**Commonwealth Edison**  
 One First National Plaza, Chicago, Illinois  
 Address Reply to: Post Office Box 767  
 Chicago, Illinois 60690

Subject: Byron Station Units 1 and 2  
Braidwood Station Units 1 and 2  
Responses to FSAR Questions  
NRC Docket Nos. 50-454, 50-455,  
50-456 and 50-457

This is to provide advance copies of information which will be included in the Byron/Braidwood FSAR in the next amendment. Attachment A to this letter lists the enclosures which contain new or revised FSAR information.

FIGURE 22.58-1 CONCENTRATION OF COMBUSTIBLES AS A FUNCTION OF TIME WITH AND WITHOUT OPERATION OF THE COMBUSTIBLE GAS CONTROL SYSTEM

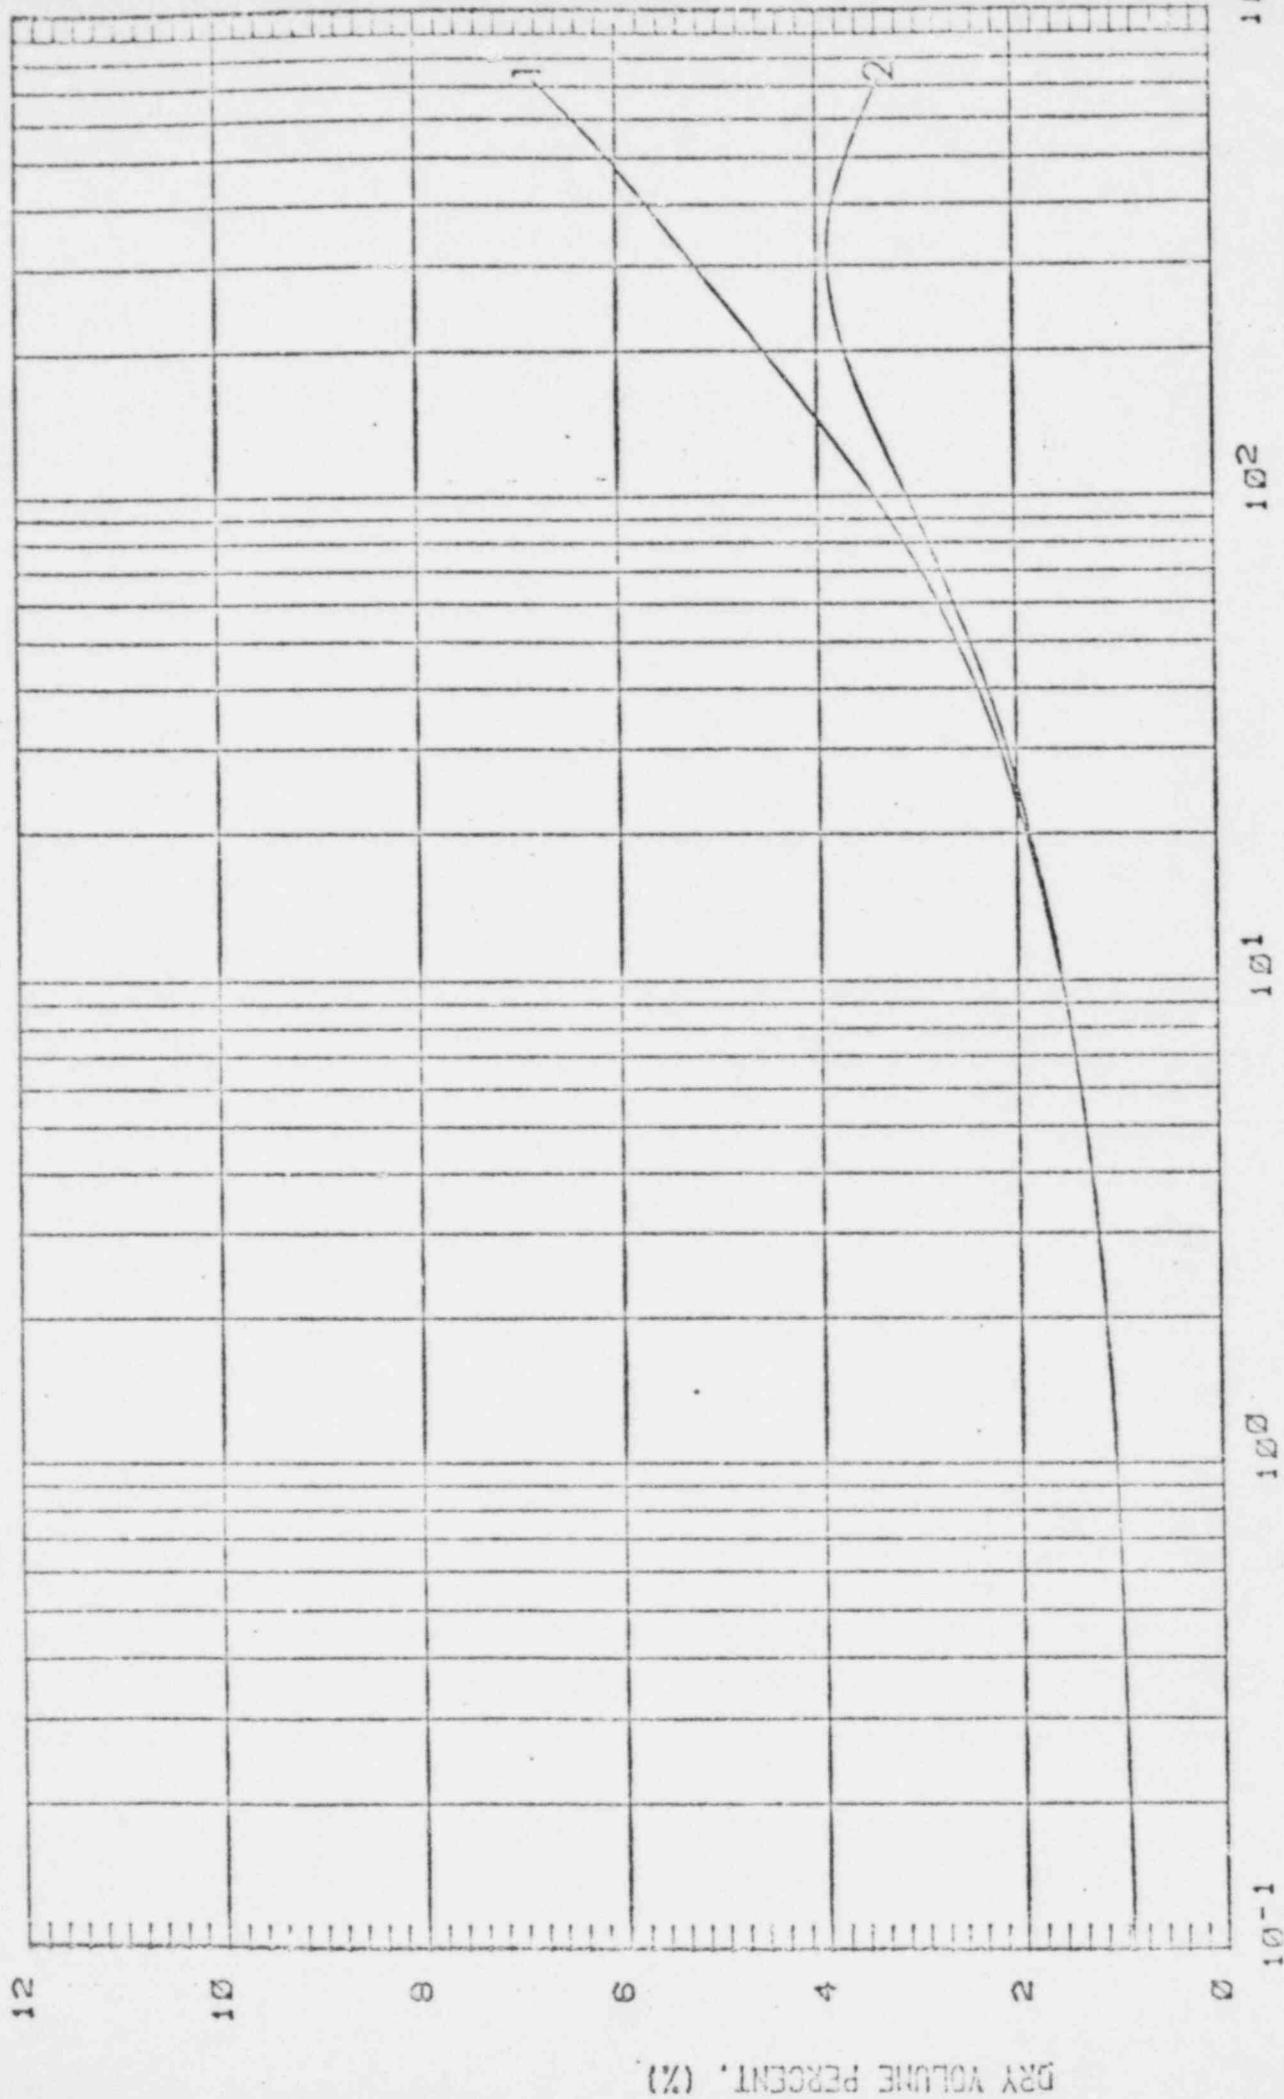
- d. The Atomics International hydrogen recombiner systems used at Byron/Braidwood have maximum operating limits of 150° F and 10 psig. Provide an evaluation which demonstrates that the containment temperature and pressure will be reduced below 150° F and 10 psig prior to the time before the hydrogen recombiners are required to operate (see Part (a) above for when hydrogen recombiner operation is required and Question No. 6.2.5-13 for concerns on which LOCA should be considered as the worst case).

- a. The hydrogen recombiner analysis has been updated to include the current 70 cfm recombiner. This will be incorporated into the FSAR. The analysis assumes that the recombiner begins operation within 4 hours of a LOCA. Only the limiting case of a single recombiner has been analyzed. The attached figure (Figure Q022.58-1) shows the results with and without the recombiner for the limiting case.

- c. The current hydrogen generation analysis assumes that the recombiner is started four hours after LOCA. This will result in a peak hydrogen concentration below 4.0%. As can be seen in Figure Q022.58-1, the recombiner has very little effect before about 10 hours due to the low hydrogen content prior to this time. Peak hydrogen
